Report FL #: 10088 for Greenheck models EHH-601D & ESD-635D (both w/ and w/o VCD-40 Damper)

Report FL #: 10093 for Airolite models SCH601MD & K6746MD (both w/ and w/o VCD-40 Damper)

NOTICE OF ACCEPTANCE (NOA)

APPROVAL DOCUMENT: Drawing No. **EHH-601D**, titled "EHH-601D Louver", sheets 1 through 35 of 35, dated 08/09/2017, prepared by Greenheck Fan Corporation, signed and sealed by Wayne K. Helmila, P.E. on 09/27/2024, bearing the Miami-Dade County Product Control revision stamp with the Notice of Acceptance number and expiration date by the Miami-Dade County Product Control Section.

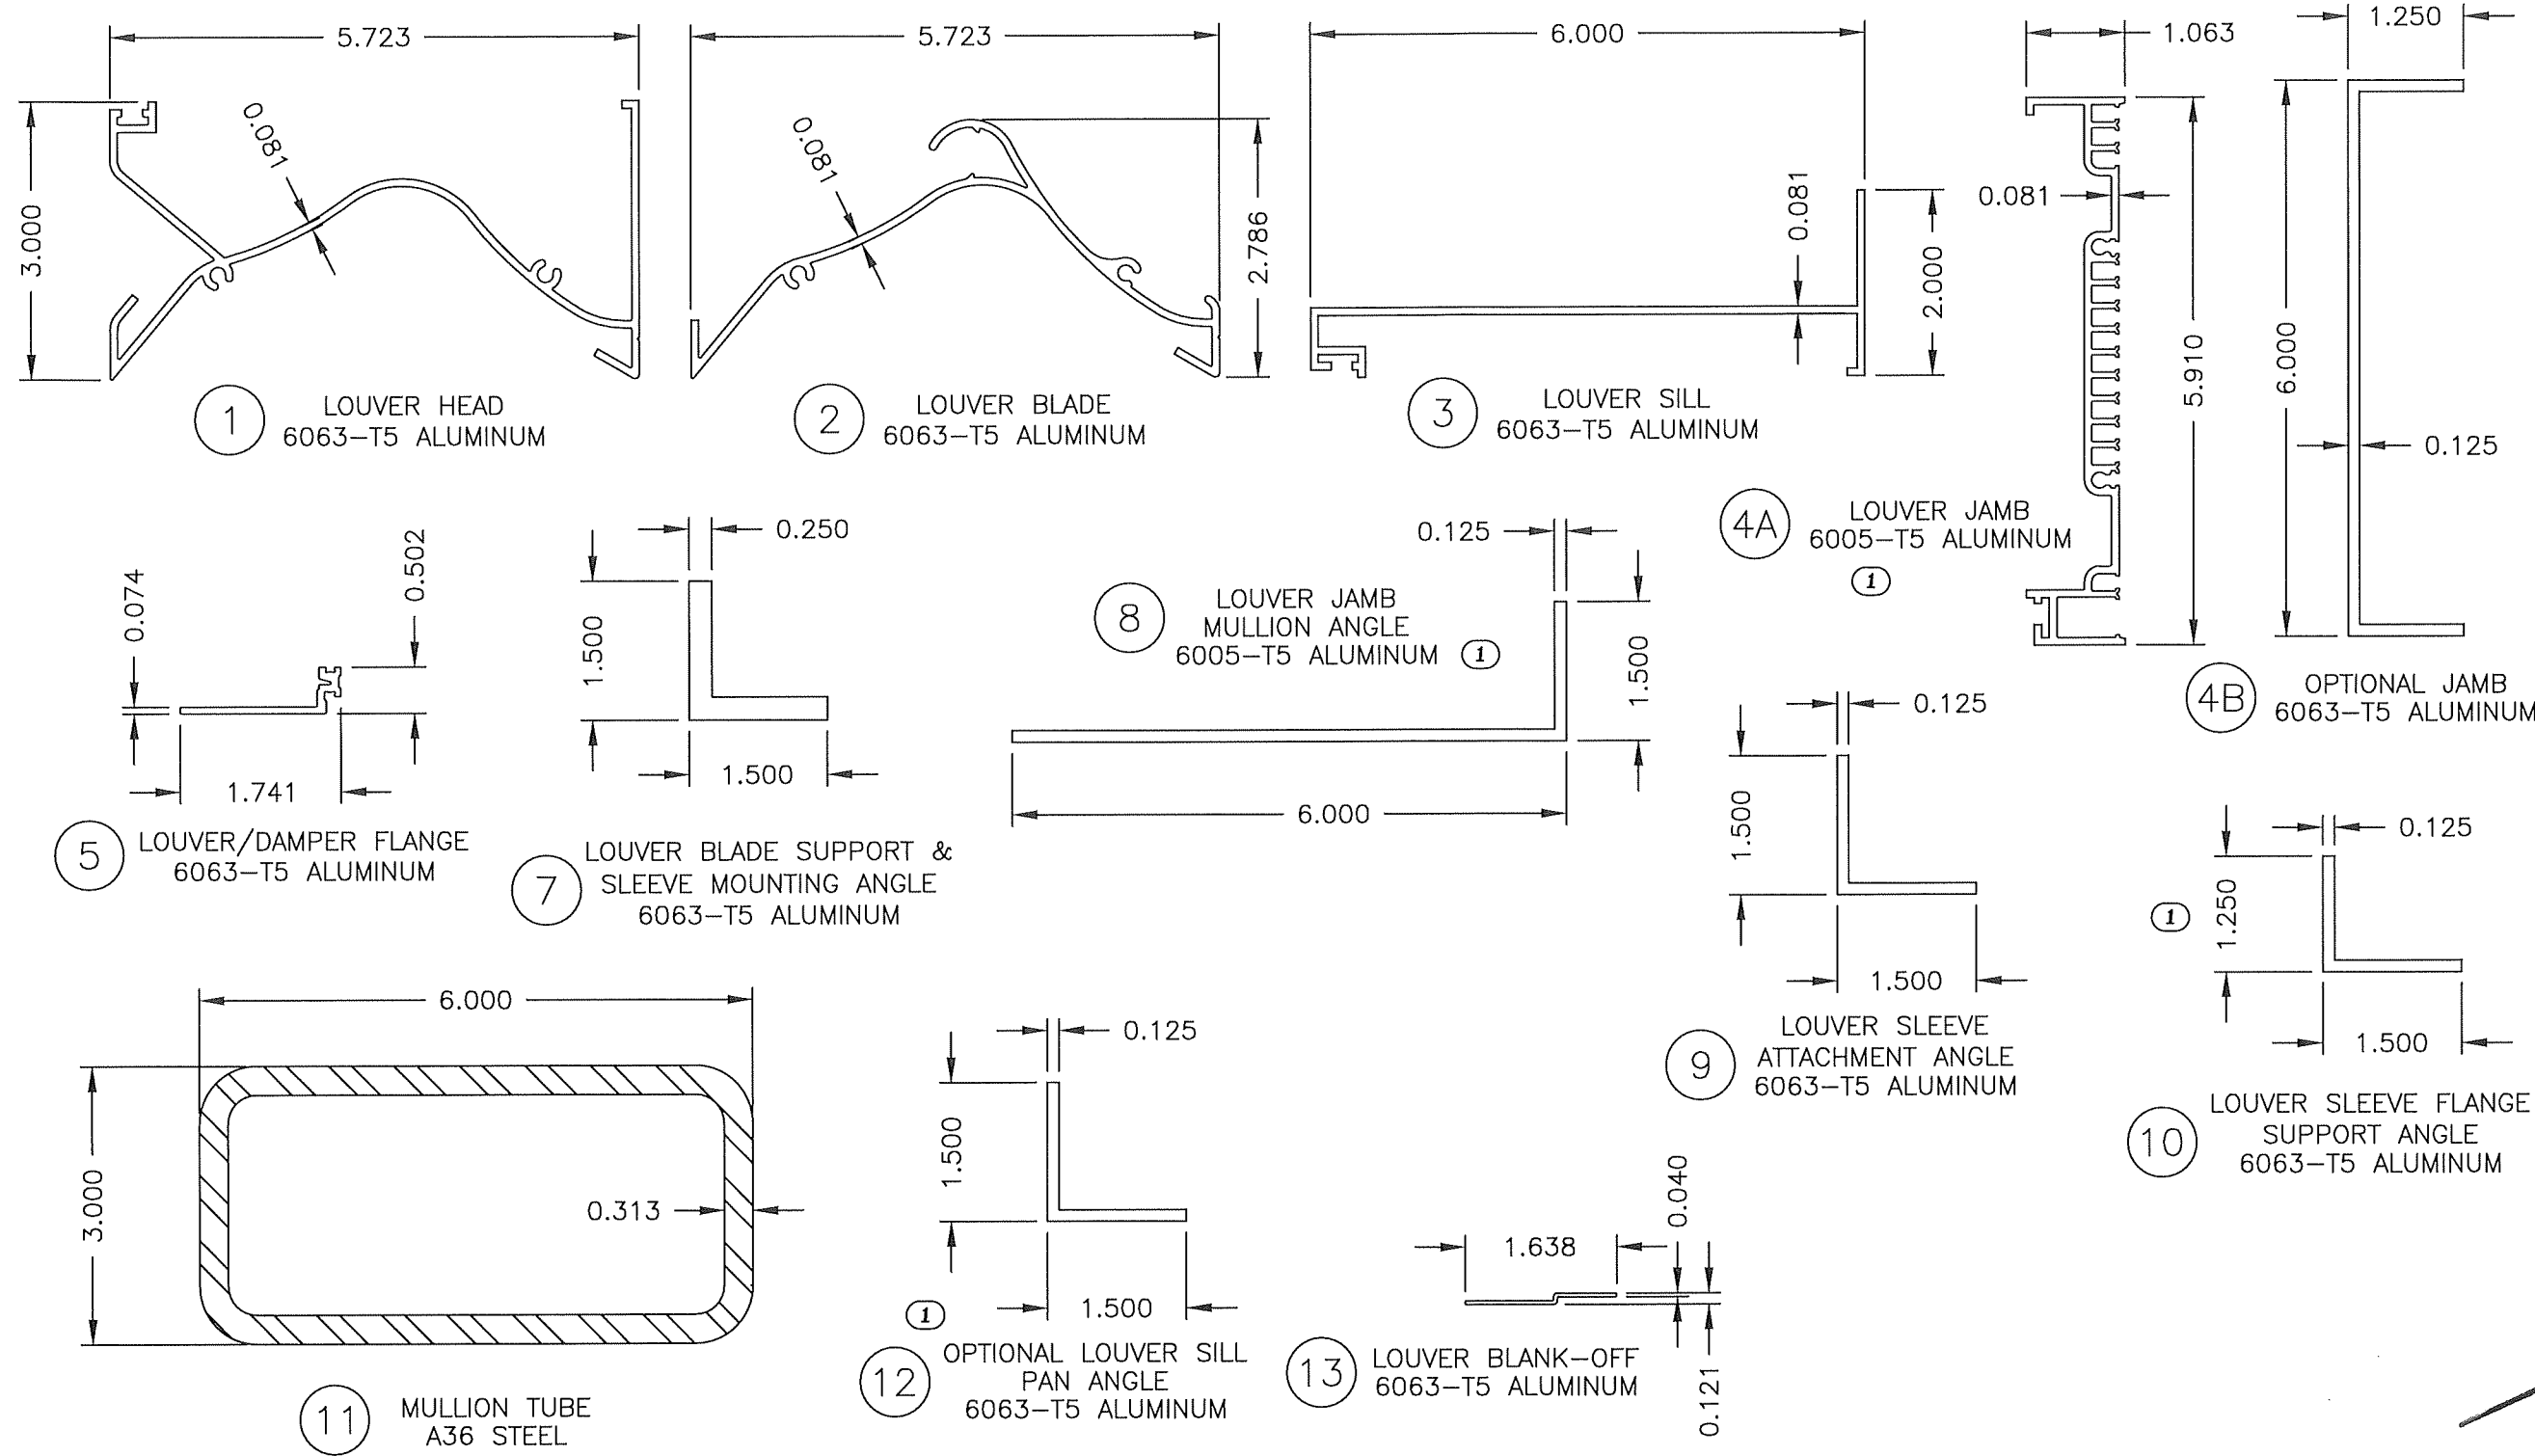
REV 01: 8/1/24, WAS PAGE 19, UPDATED ALLOY OF ITEMS 4A & 8,
 CORRECTED LENGTH OF ITEM 10, & ADDED OPTIONAL TO ITEM 12.

GREENHECK P.O. BOX 410 SCHOFIELD, WISCONSIN 54476-0410 TITLE EHH-601D LOUVER FLANGE FRAME SLEEVE MOUNT & CONTINUOUS ANGLE MOUNT PART PROFILES	DRAWN BY MES	DATE 8/9/2017	SHEET NO. 25 OF 35 CAD DRAWING NO. EHH-601D
	SCALE	SCALE

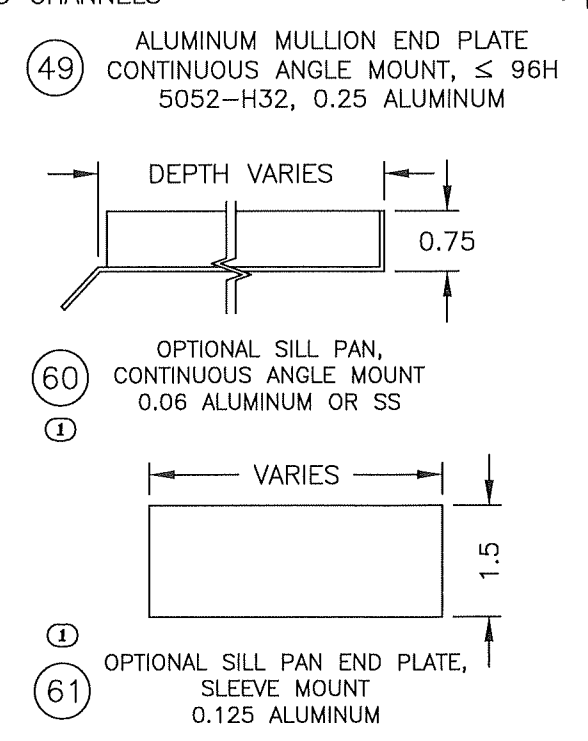
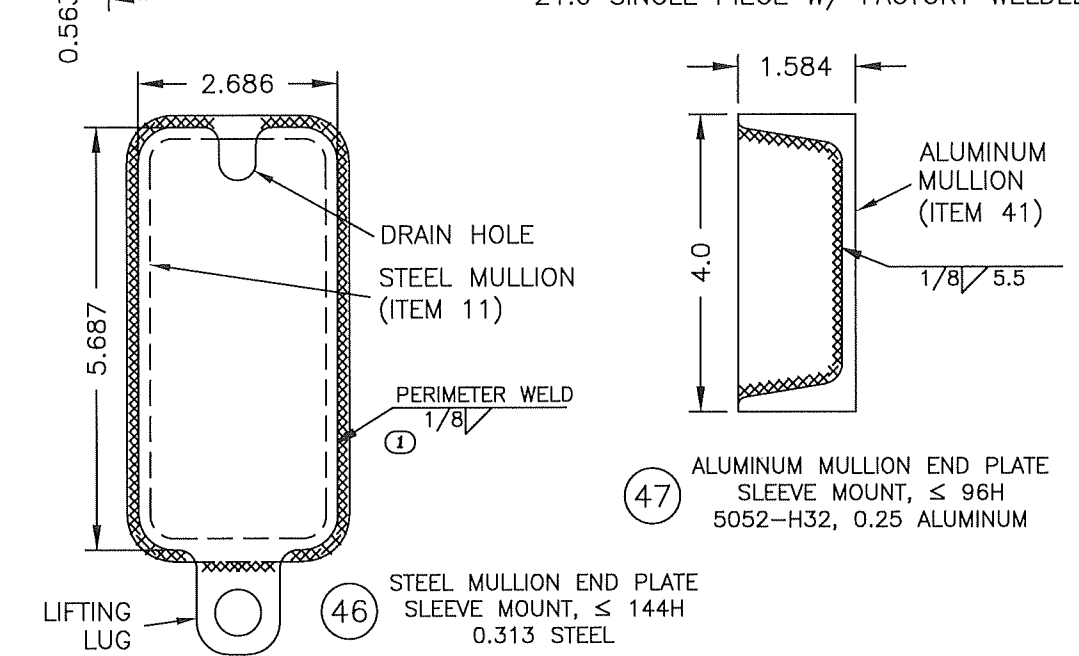
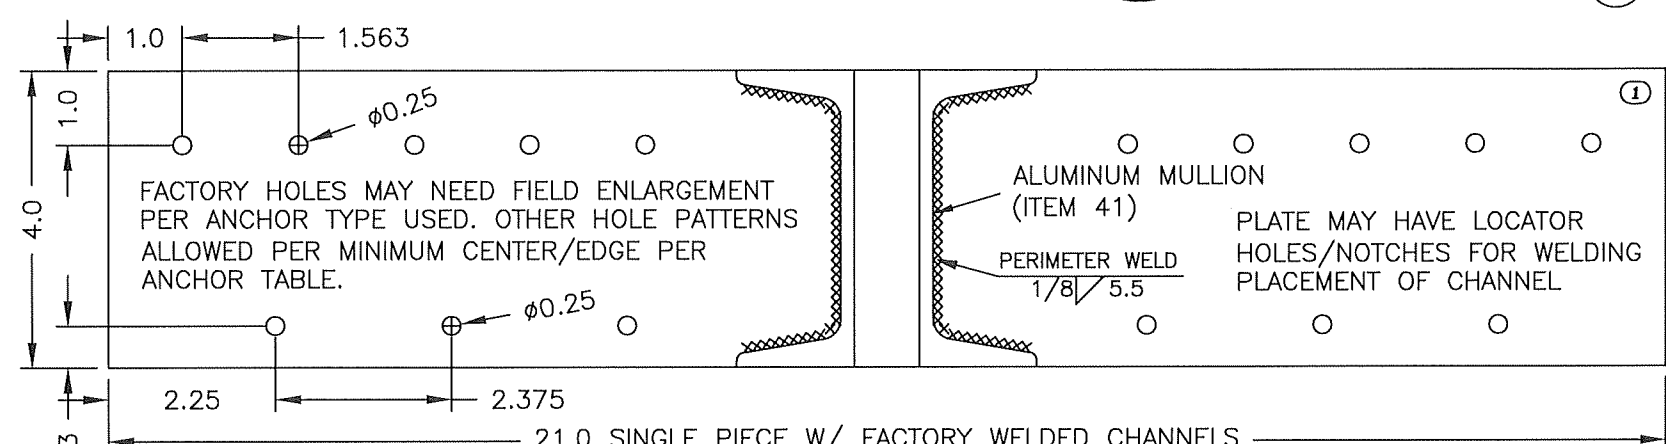
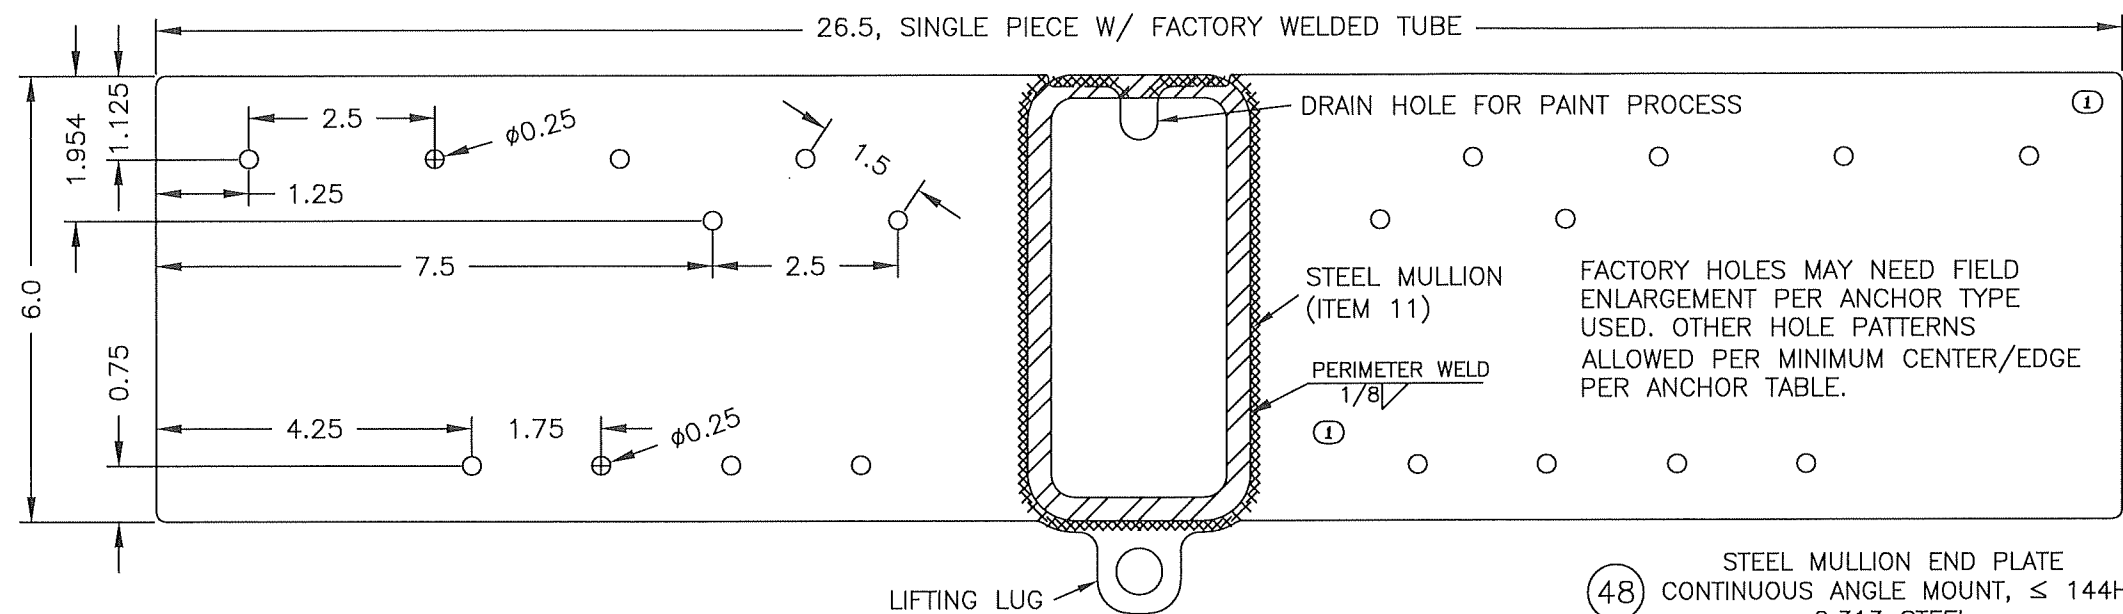
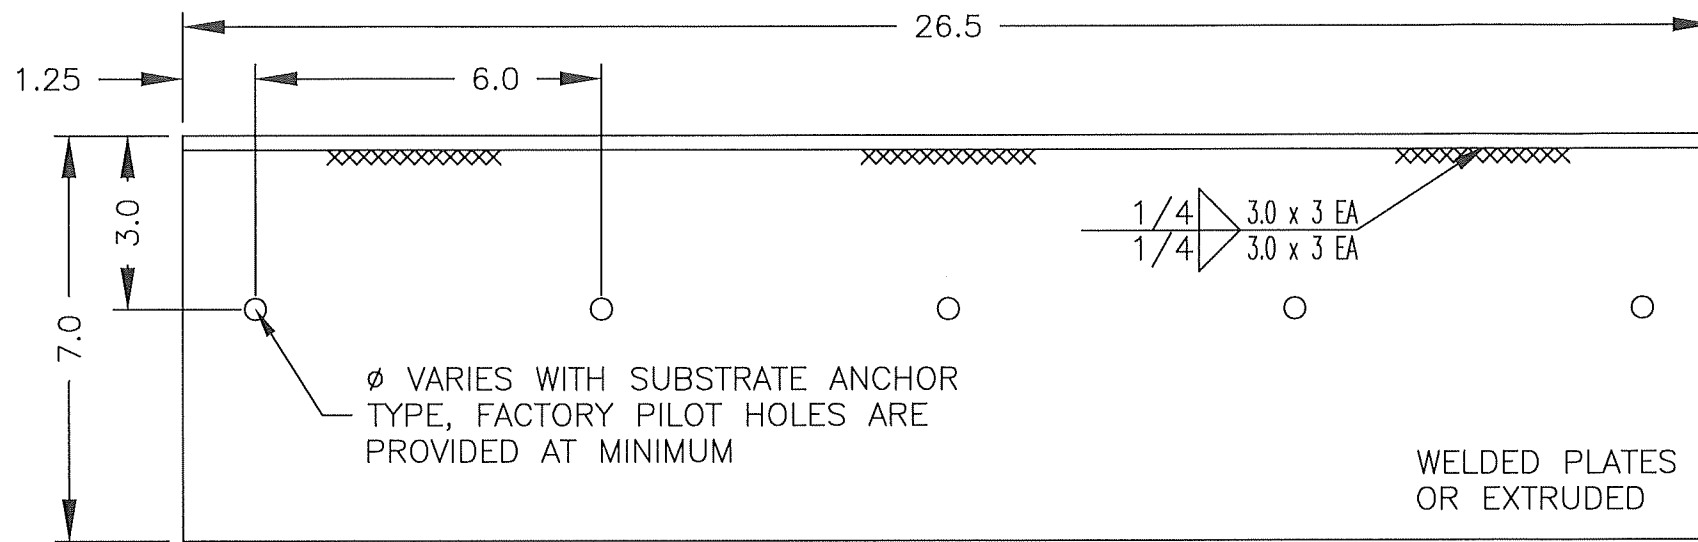
REV 01: 8/1/24, WAS PAGE 21, CORRECTED WELD SIZE OF ITEMS 46 & 48, UPDATED PROFILE & HOLE LAYOUTS OF ITEMS 48 & 49, MOVED ITEM 50 TO NEW PAGES, REMOVED STEEL ANGLE OPTIONS, & ADDED ITEMS 60 & 61.

DRAWN BY MES	DATE 8/9/2017	 P.O. BOX 410 SCHOFIELD, WISCONSIN 54476-0410 	SCALE	SHEET NO.	26 OF 35	CAD DRAWING NO.	EHH-601D

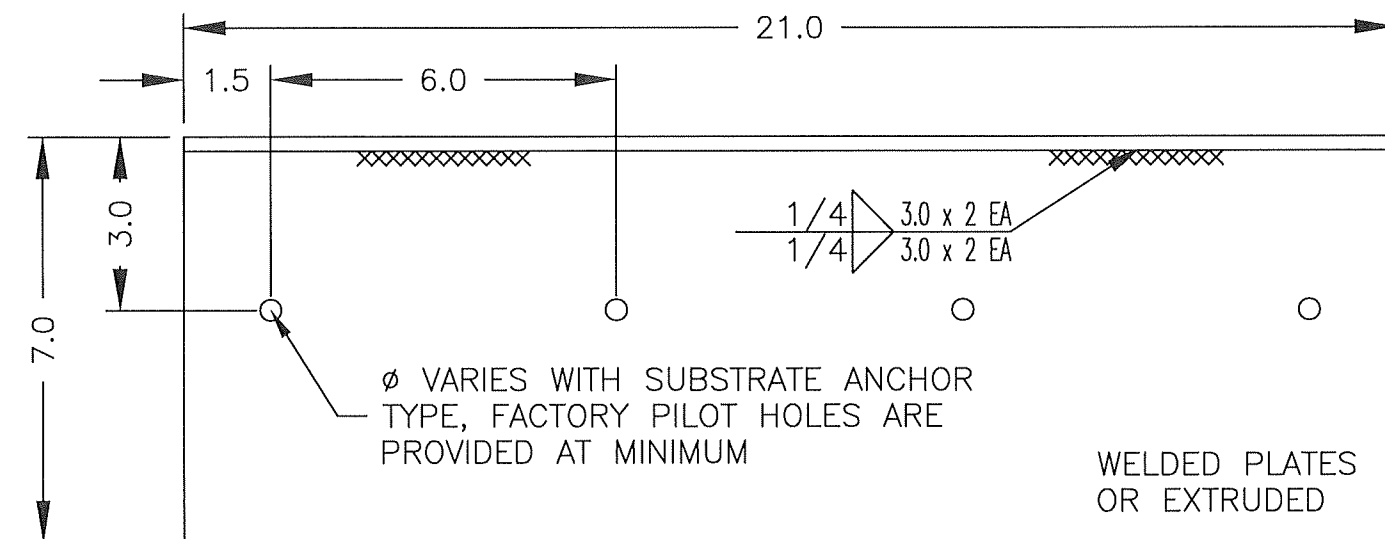
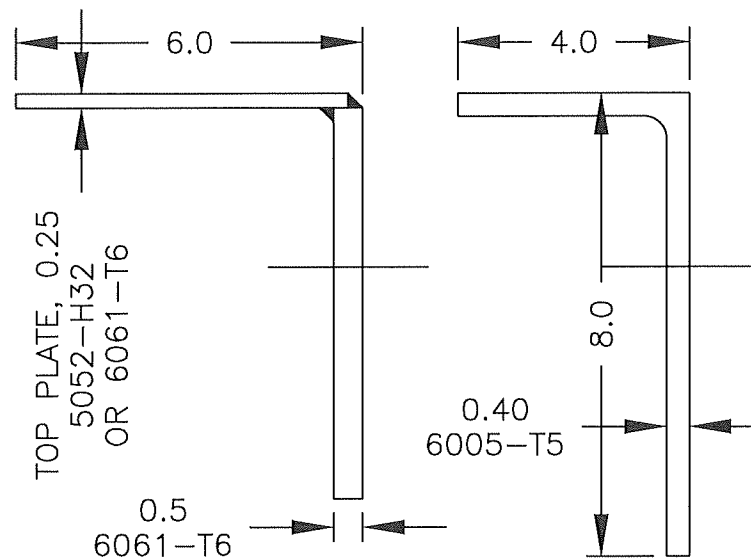
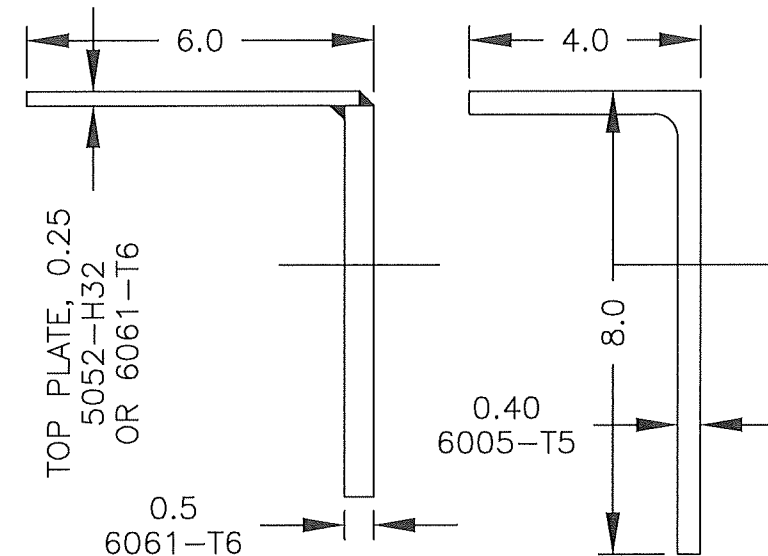
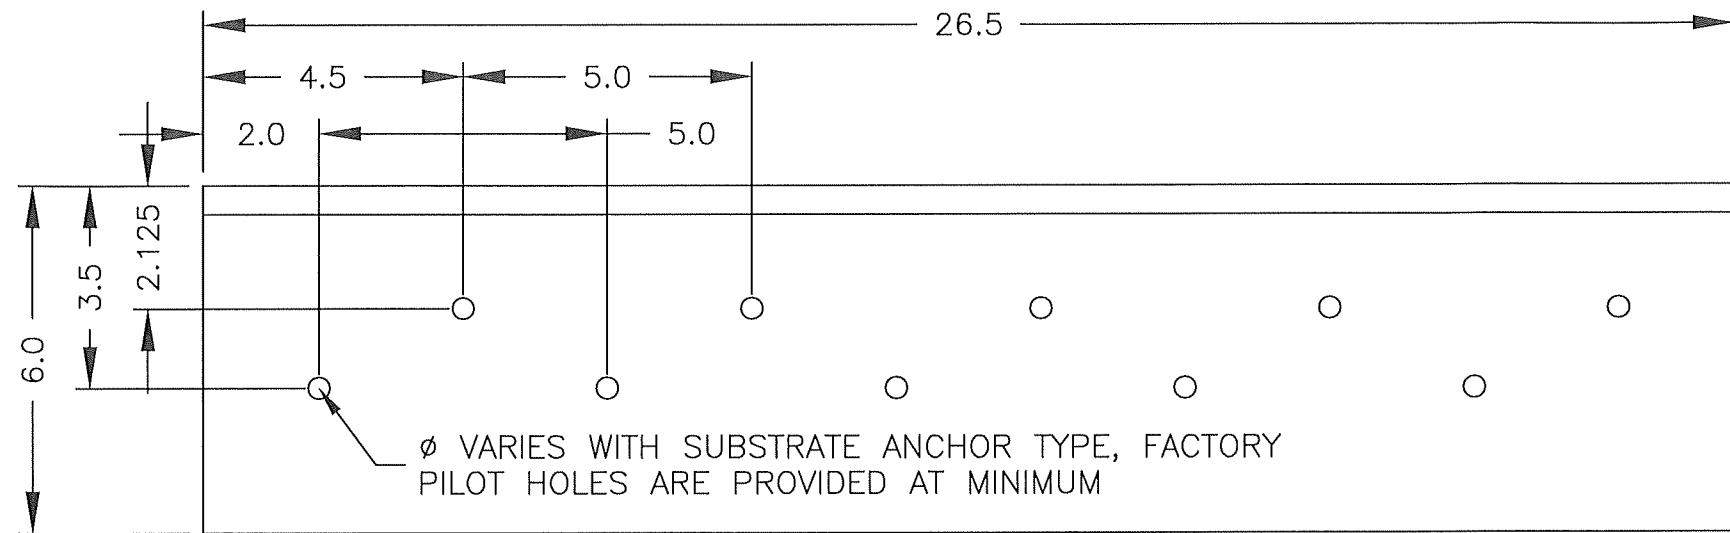
REV 01: 8/1/24, MOVED ITEM 50 TO THIS NEW PAGE & SPLIT IT INTO SIX
ITEMS WITH 50A1/B1 ON THIS PAGE & ITEMS 50A2/B2 & 50A3/B3 ON
ANOTHER NEW PAGE, UPDATED HOLE PATTERNS & LENGTH OF ITEMS 50A1/B1.
